Office Action Summary	Application No. 10/665,040	Applicant(s) LIN, WARREN	
	Examiner Melody M. Burch	Art Unit 3683

(54) **VENTED DISC BRAKE ROTOR**

[54] DISC BRAKES

Fig-1

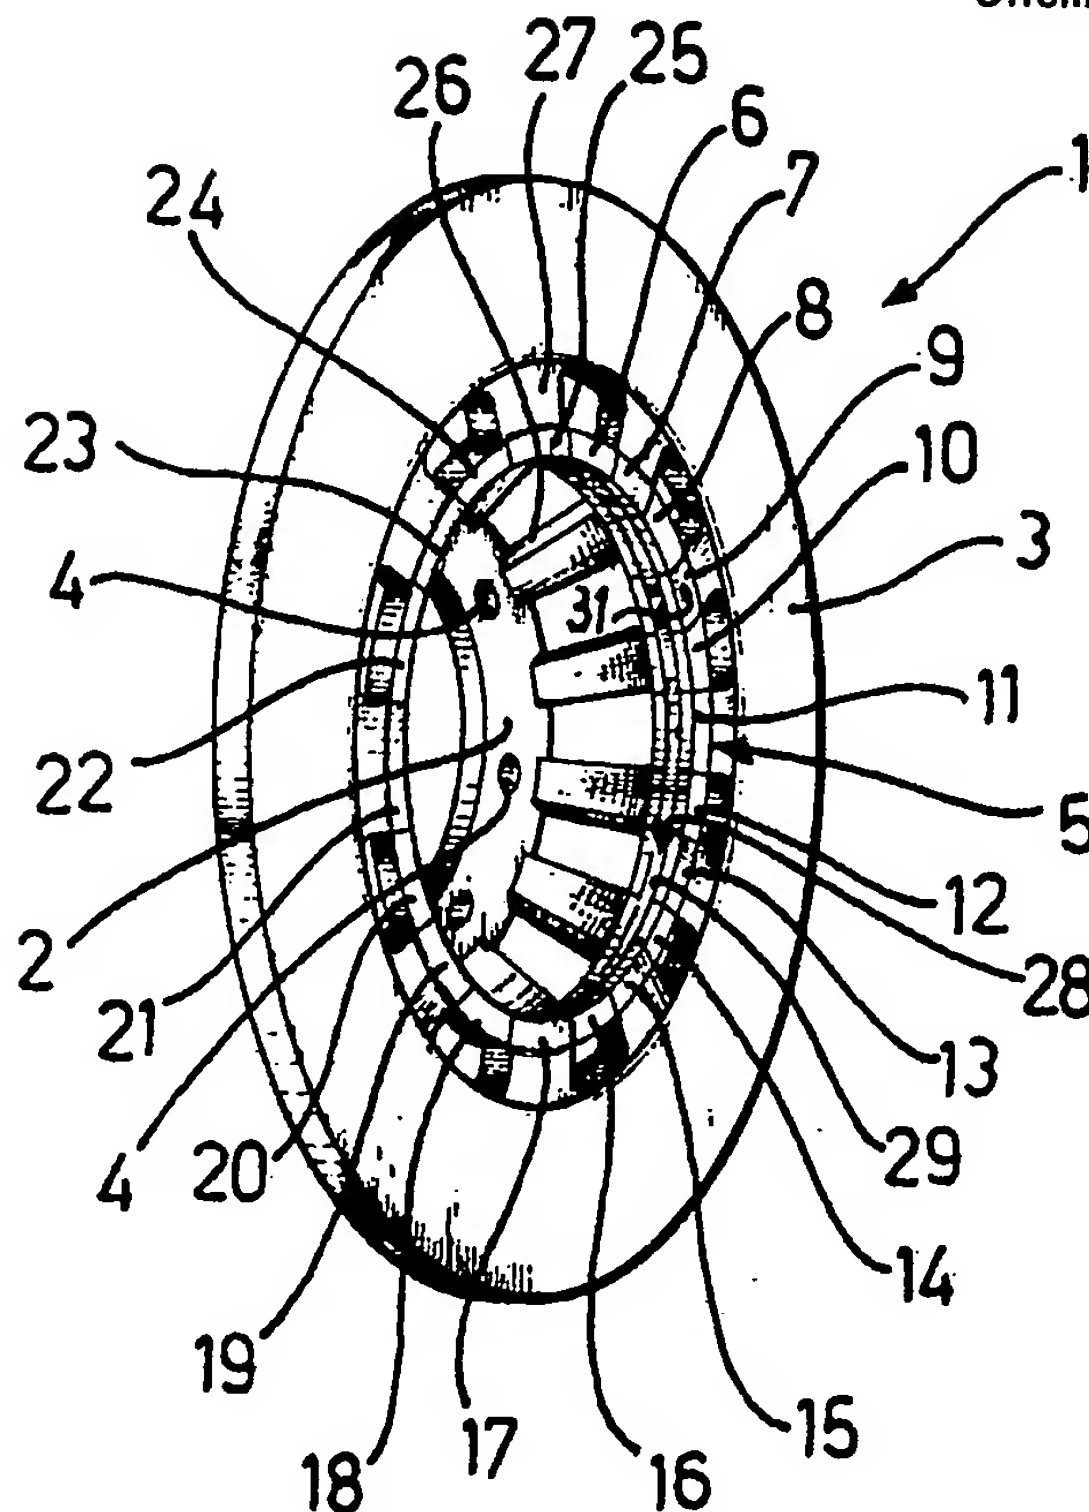
Re: claims 1, 22, and 26. DE'108 shows in figure 1 a brake rotor 3 comprising a central mounting portion 2 for mounting the brake rotor on a hub, a first annular braking surface and a second annular braking surface, wherein each braking surface includes an inner diameter and an outer diameter, a bridge 27,29 provided between the central mounting portion and the inner diameter of at least one of the first and the annular braking surfaces, and a plurality of ribs 26 positioned proximate to the bridge.

DE'108 includes the limitation wherein the central mounting portion, the braking surfaces, the bridge, and the ribs are formed in a single piece under assembly via the element 29 as shown in figure 1.

Re: claim 3. DE'108 shows in figure 1 the limitation wherein the bridge includes a plurality of openings or spaces enclosed by elements 27 and element 29.

Re: claim 8. DE'108 shows in figure 1 the limitation of the rotor further comprising a hat portion or inner cylindrical wall of element 2 disposed in the central portion and adapted for mounting the rotor to a vehicle.

Re: claims 1 and 4. In an alternate interpretation, DE'108 shows in figure 1 a brake rotor 3 comprising a central mounting portion 2 for mounting the brake rotor on a hub, a first annular braking surface and a second annular braking surface, wherein each braking surface includes an inner diameter and an outer diameter, a bridge 26,29 provided between the central mounting portion and the inner diameter of at least one of the first and the annular braking surfaces, and a plurality of ribs 27 positioned proximate to the bridge.

DE'108 includes the limitation wherein the central mounting portion, the braking surfaces, the bridge, and the ribs are formed in a single piece under assembly via the element 29 as shown in figure 1.

Fig-2

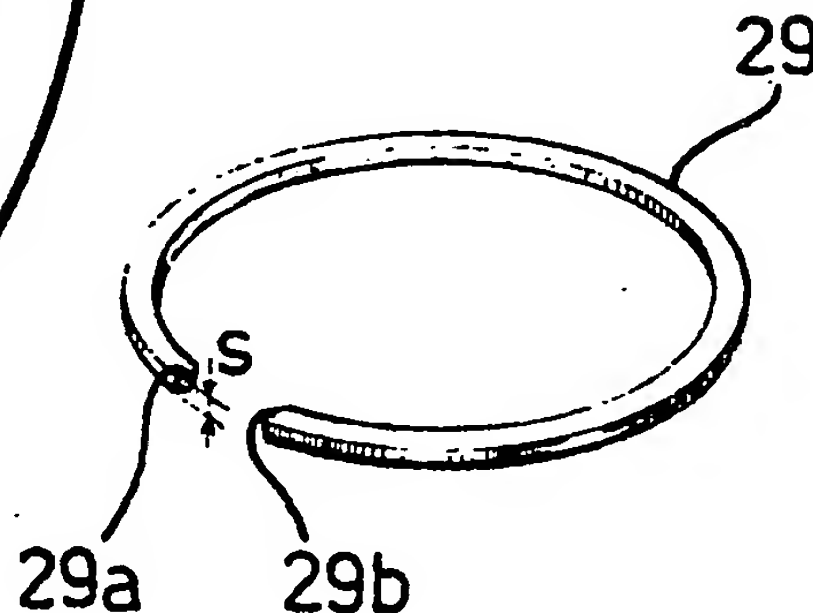
Re: claims 1, 22, and 26. Russell et al. show in figure 2 a brake rotor shown in the area of element 5 comprising a central mounting portion or mounting bore in top element 9 for mounting the brake rotor on a hub 1, a first annular braking surface to the left of the lead line of number 3 and a second annular braking surface 5, wherein each braking surface includes an inner diameter and an outer diameter, a bridge or solid portion of top element 9 provided between the central mounting portion and the inner

Re: claim 2. Russell et al. show in figure 2 the limitation wherein the bridge 9 is substantially solid and wherein at least a portion of at least one rib (remaining elements 9) protrudes above a surface (particularly a bottom surface) of the bridge.

Re: claim 5. Russell et al. show in figure 2 the limitation wherein at least one of the plurality of ribs are integral to a side of a flow channel shown between elements 7 of a vented brake rotor.

Re: claims 7, 9. Russell et al. show in figure 2 the brake rotor comprising one or more pairs of openings or areas between elements 7, each pair of openings allowing communication between the first annular braking surface and the second annular braking surface or in an alternate interpretation the one or more pairs of openings may be the holes in the ribs 9. In the alternate interpretation the vent would be the space between adjacent elements 7.

Re: claims 1, 22, and 26. In an alternate interpretation of the Russell et al. reference, Russell et al. show in figure 2 a brake rotor shown in the area of element 5 comprising a central mounting portion or element 1 for mounting the brake rotor on a hub shown immediately to the left of the lead arrow of number 15, a first annular braking surface to the left of the lead line of number 3 and a second annular braking surface 5, wherein each braking surface includes an inner diameter and an outer diameter, a bridge or all elements 9 provided between the central mounting portion and the inner diameter of at least one of the first and the annular braking surfaces, and a plurality of ribs 7 positioned proximate to the bridge.

Re: claims 3 and 18. Russell et al. show in figure 2 the limitation wherein the rotor comprises a plurality of openings positioned in the bridge or the apertures shown in each of elements 9.
